ENVIRONMENTAL ASSESSMENT
BY THE OFFICE OF NUCLEAR MATERIAL SAFETY AND SAFEGUARDS
OF THE PROPOSED DECOMMISSIONING PLAN AND OTHER PROPOSALS

RELATED TO THE
CIMARRON CORPORATION
FORMER FUEL FABRICATION FACILITY

DOCKET NO. 70-0925

JULY 29, 1999

Figure 6.1: Resident-Farmer Scenario Doses for the Cimarron Disposal Cell With Cover

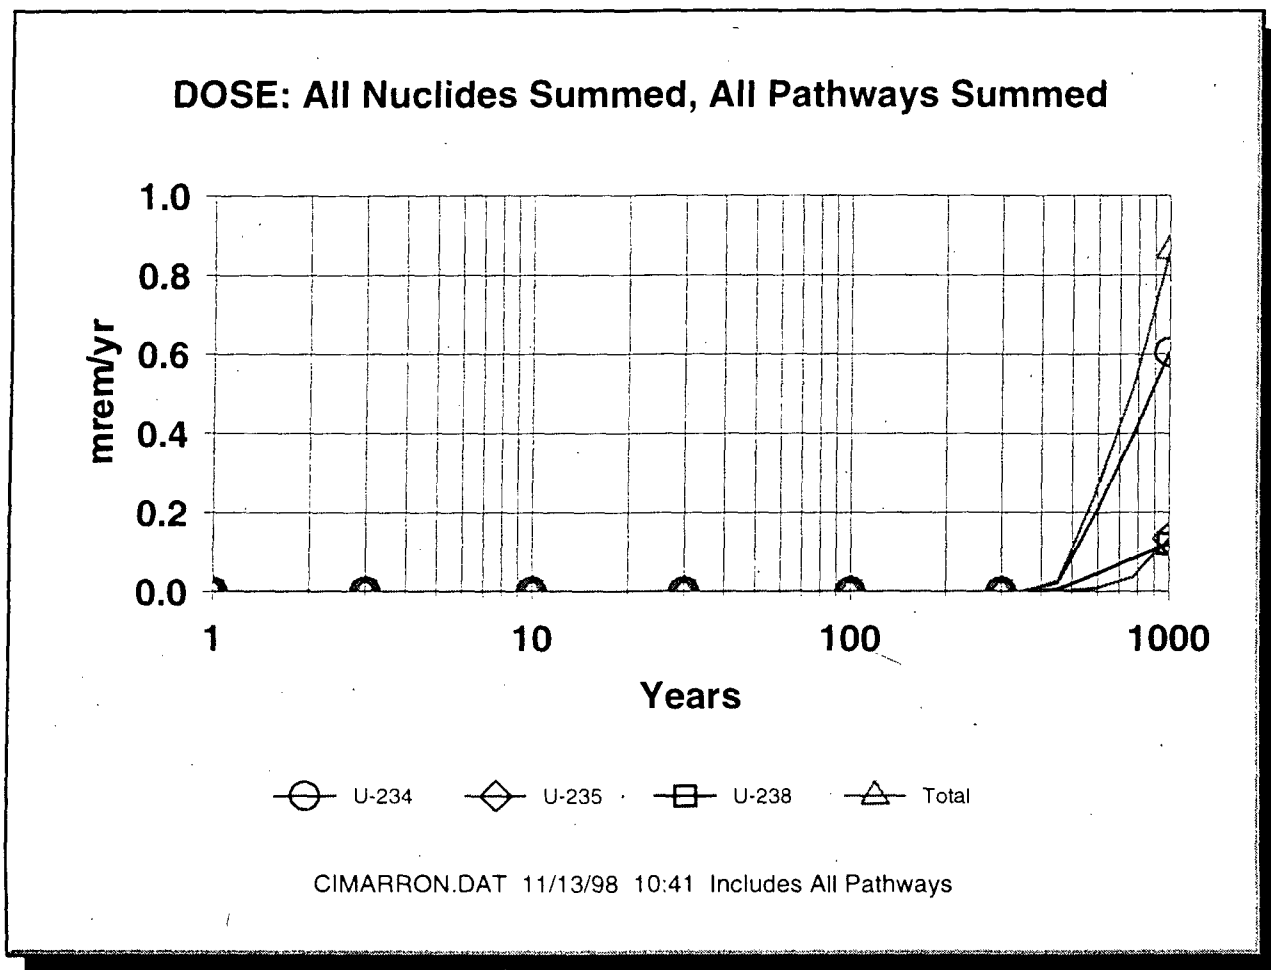
The result of the calculation is shown in Figure 6.1. The dose was estimated for a time period of 1000 years. The maximum dose from soil contamination for the uranium concentration is estimated as 0.0086 mSv/yr (0.86 mrem/yr) at 1000 years. The dose is almost zero for several hundred years after the disposal cell is closed.

Figure 6.2: Resident-Farmer Scenario Doses for the Cimarron Disposal Cell With No Cover

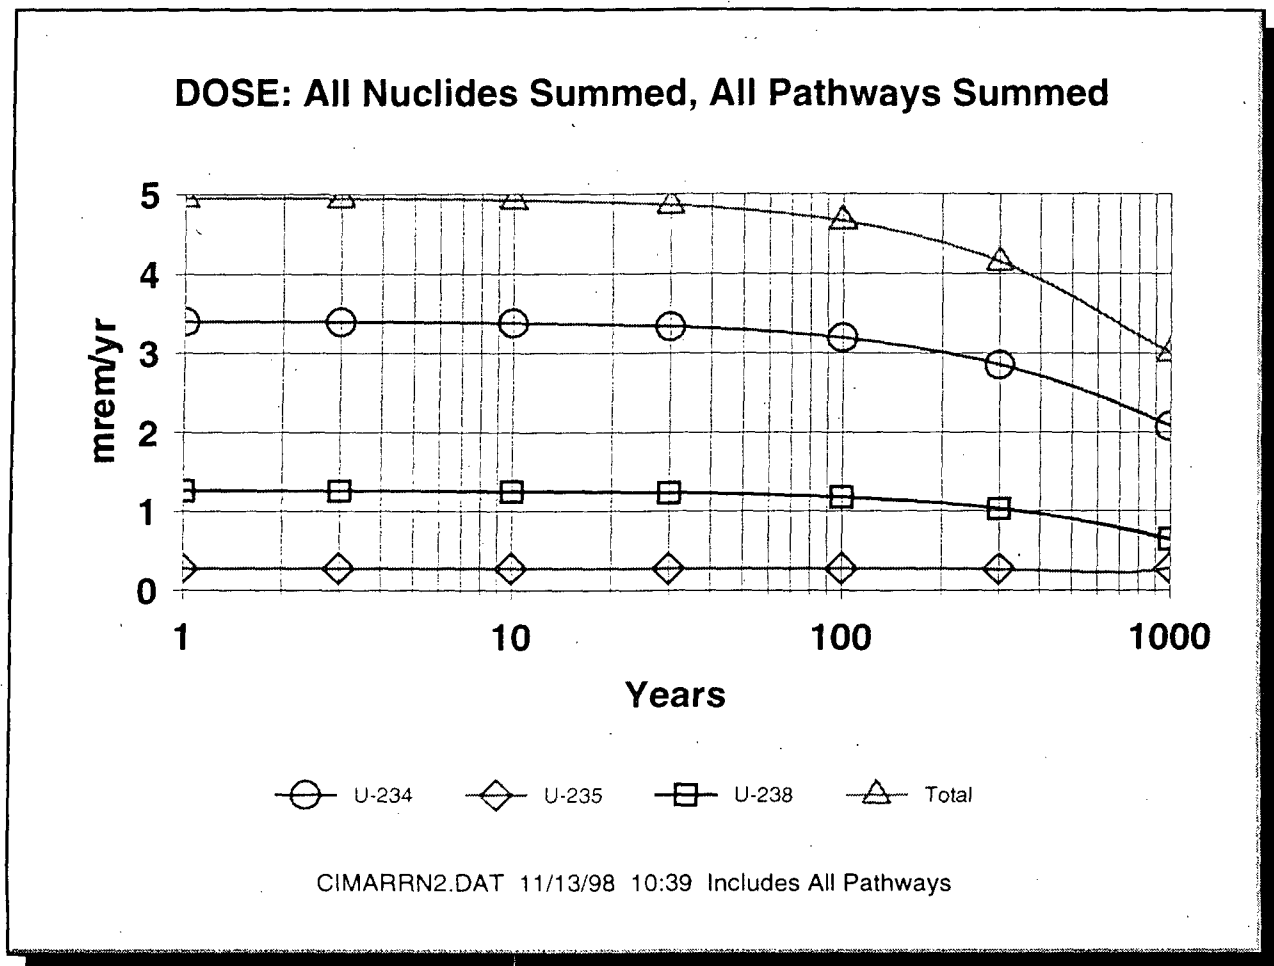
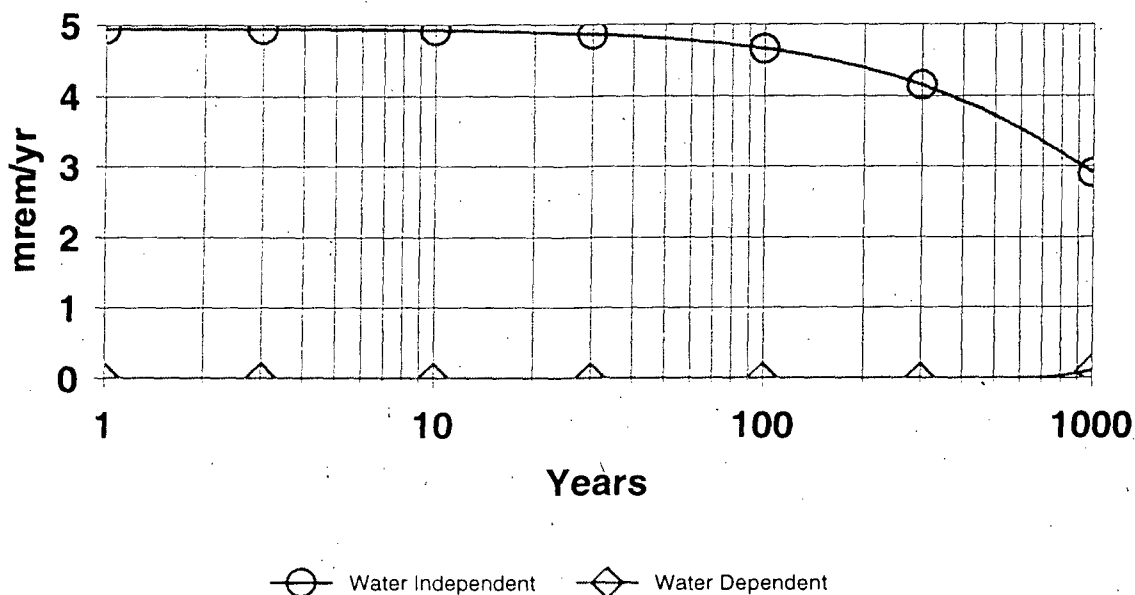
For comparison purposes, another dose assessment was performed assuming that no soil cover was over the contaminated material. The maximum dose from soil contamination is estimated as 0.049 mSv/yr (4.96 mrem/yr) at zero years, as shown in Figure 6.2.

In both the cover and no-cover cases, doses during the first 1000 years result from the groundwater independent pathways (inhalation, ingestion, and direct exposure). Figure 6.3 shows the water-independent and the water-dependent pathways for the no-cover, resident-farmer scenario.
